DIAMOND PLACE ESTATES SUBDIVISION

APPLICATION NUMBER 5 DATE July 7, 2016

REQUEST Subdivision

DETAIL SITE PLAN

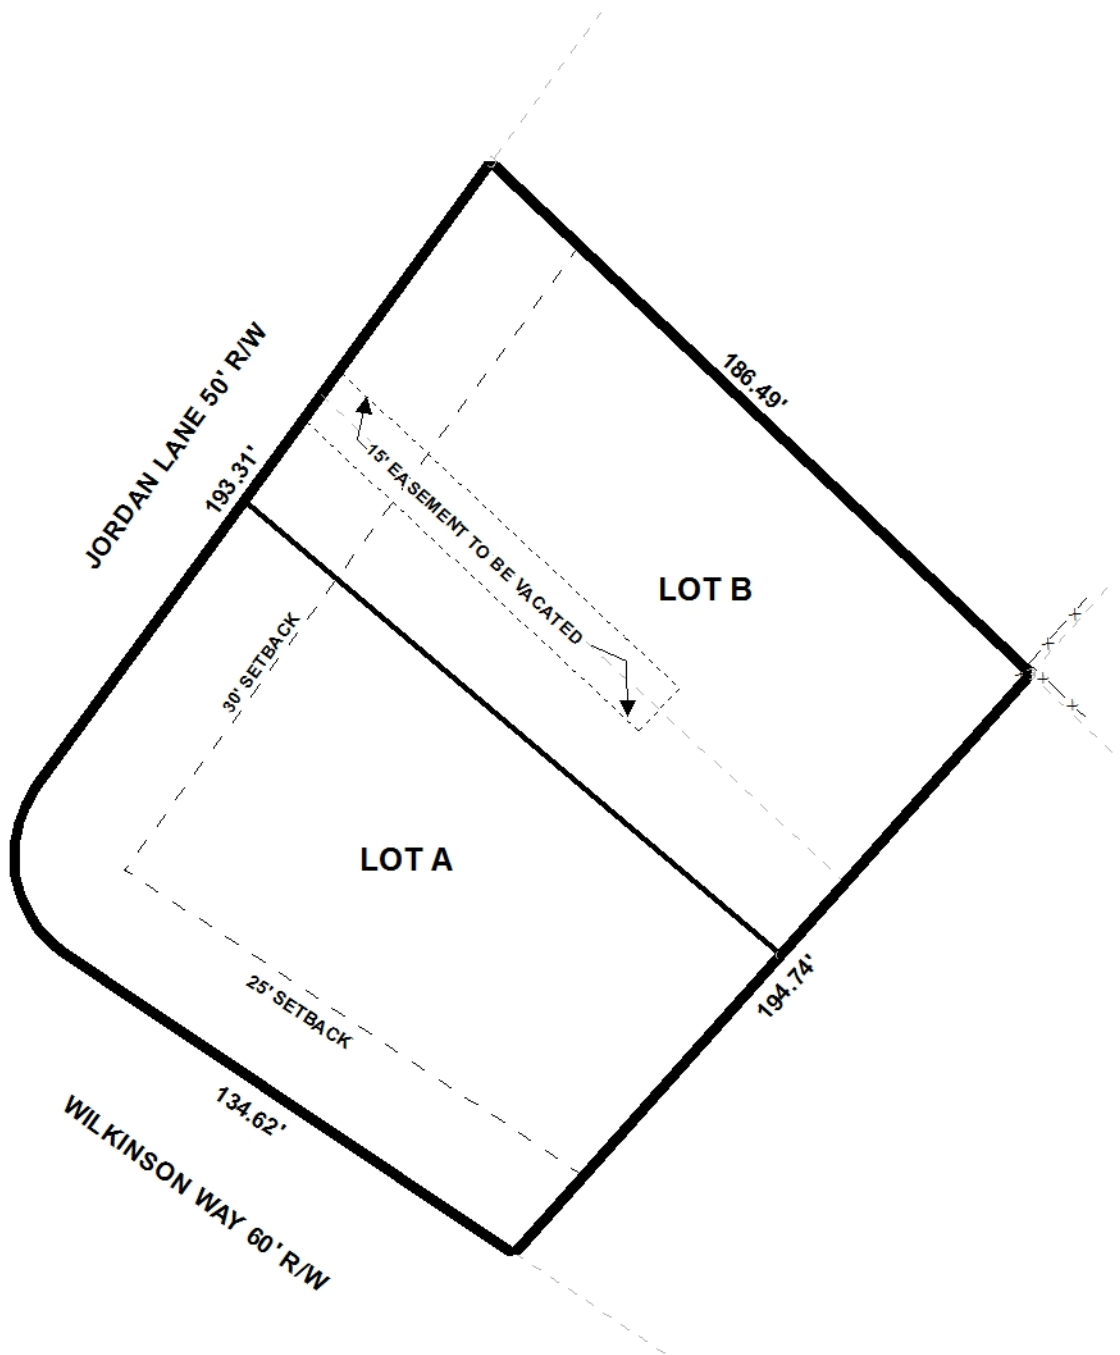
C. Clarify the status of the vacated easement (Note #17) and correct the label and note.

The proposed lots appear to meet the maximum width to depth ratio as regulated by Section V.D.3. of the Subdivision Regulations. The lot sizes in square feet and acres are depicted on the plat should be retained on the Final Plat, if approved.

The site has frontage onto Wilkinson Way a minor street with valley gutter and with a right-of-way width of 60 feet; and Jordan Lane, also a minor street with valley gutter but with a right-of-way width of 50'. An increased minimum building setback has been provide along Jordan Lane, thus no additional dedication will be required.

The 25' minimum building setback line along Wilkinson Way as well as the 30' minimum building setback along Jordan Lane should be retained on the Final Plat, if approved.

The site has property lines at an intersection corner (Jordan Lane and Wilkinson Way). Section V.D.6. of the Subdivision Regulations requires that "*property lines at street intersection corners shall be arcs having radii of at least 10 feet or shall be chords of such arcs*". The curb radii is depicted on the preliminary plat, and if approved should be depicted on the Final Plat as well.

It should be noted, the preliminary plat depicts a 15' utility easement on the proposed Lot B, along with a note that reads, "vacation of unused utility easement at the rights of the property owners as recorded in mapbook 129, page 94". Provision of documentation depicting the vacation of the utility easement on the proposed Lot B will be required prior to the signing of the Final Plat.

- 1) submission of 7 copies of the Resubdivision Lot 19, First Unit of New Country Club Estates Subdivision to the Planning and Zoning Department prior to the signing of the Final Plat;
- 2) documentation depicting vacation of the utility easement located on Lot B prior to the signing of the Final Plat;
- 3) retention of the minimum building setback lines on both Lot 1 and Lot 2;

- 4) retention of the lot sizes in square feet and acres;
- 5) retention of the curb radii;
- 6) placement of a note on the final plat stating that each lot is limited to one (1) curb-cut each, with the size, design and location of all curb-cuts to be approved by Traffic Engineering and conform to AASHTO standards;
